**BAKERSFIELD CITY SCHOOL DISTRICT
(10) 24X40 TEMPORARY PORTABLE CLASSROOMS
AT ROOSEVELT ELEMENTARY SCHOOL
BAKERSFIELD, KERN COUNTY, CALIFORNIA**

Job No. 1317.1
Appl. No. 15-6
File No. 03-123198

ADDENDUM NO. #02

STD BCSD 24x40 CR BLDG
7-7-22

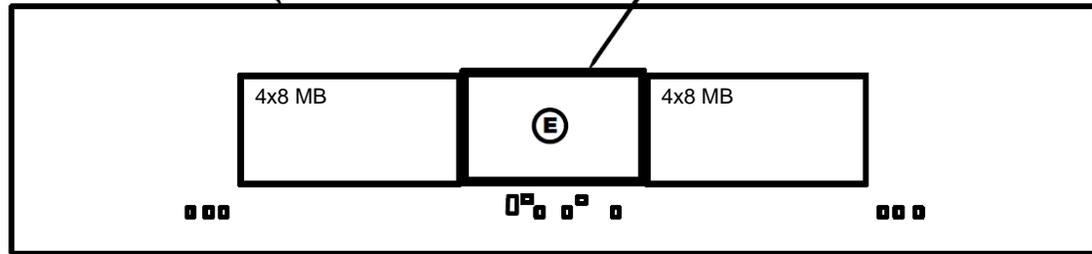
- a. DELETE: Drawing BCSD 30x32 CR BLDG. See also Item 2-2b. of this Addendum.
- b. ADD: The following item:
#27 Provide and install data for smart board and installation of District provided smart board as shown on attached Drawing BCSD 24x40 CR BLDG and BCSD smart board/LCD installation methods and requirements document as attached to this Addendum.

9' CEILING HT. SMARTBOARD LOCATION
BCSD TO PROVIDE, CONTRACTOR TO INSTALL

- (A) INSTALL/TERMINATE 3 CAT6 DATA CABLES INTO 3 PORT FACEPLATE
- (B) INSTALL/TERMINATE 2 CAT6 DATA CABLES INTO 3 PORT FACEPLATE
USE BLANK ON 3RD PORT
- (C) INSTALL/TERMINATE 2 CAT6 DATA CABLES ABOVE CEILING TILE
LEAVE COIL BOTH CABLES UP AND ATTACH TO J-HOOK
30FT SPARE LENGTH
- (D) INSTALL/TERMINATE 2 CAT6A DATA CABLES INTO 2 PORT FACEPLATE
ATTACH FACEPLATE TO A 1G LOW VOLTAGE BRACKET INSTALLED IN CEILING TILE
- (E) DISTRICT PROVIDED SMARTBOARD AND ASSOCIATED EQUIPMENT TO BE INSTALLED
ACCORDING TO BCSD SMARTBOARD/LCD INSTALLATION METHODS AND REQUIREMENTS
- (F) INSTALL CEILING MOUNTED CLASSROOM SPEAKER
SPEAKER TO BE CONNECTED/PROGRAMMED TO DISTRICT P/BELL SYSTEM
VALCOM CLASS CONNECTION
